UNITED STATES PATENT AND TRADEMARK OFFICE

APPLICATION NO.	FILING DATE	FIRST NAMED INVENTOR	ATTORNEY DOCKET NO.	CONFIRMATION NO.
10/795,891	03/08/2004	Ryan Cameron Lakin	14977-0006	1521
25267 7590 06/02/2008 BOSE MCKINNEY & EVANS LLP 2700 FIRST INDIANA PLAZA 135 NORTH PENNSYLVANIA INDIANAPOLIS, IN 46204				
EXAMINER				
HOFFMAN, MARY C				
ART UNIT		PAPER NUMBER		
3733				
MAIL DATE		DELIVERY MODE		
06/02/2008		PAPER

Office Action Summary

DETAILED ACTION

Sheet 1 of 10

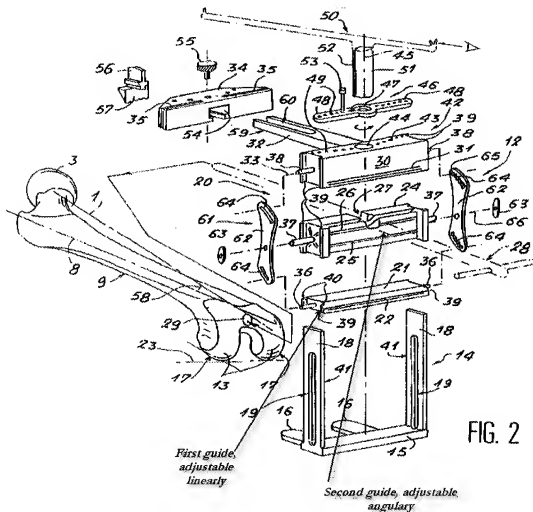
Applicant's arguments filed 10/17/2007 have been fully considered but they are not persuasive. Applicant argues that the device of Duvillier et al does not include a first guide defining a first cutting path having a position, the position of the first cutting path relative to the first mounting location being adjustable linearly using a grip of the first adjustor and a second guide defining a second cutting path having a position, the position of the second cutting path relative to the first mounting location being adjustable angularly using a grip of the second adjustor. The examiner respectfully disagrees. Duvillier discloses a first guide defining a first cutting path having a position, the position of the first cutting path relative to the first mounting location being adjustable linearly using a grip of the first adjustor and a second guide defining a second cutting path having a position, the position of the second cutting path relative to the first mounting location being adjustable angularly using a grip of the second adjustor (e.g., see the marked up figure below).

Also, in FIG. 2A, components ref. #30 and 205 appear angularly adjustable.
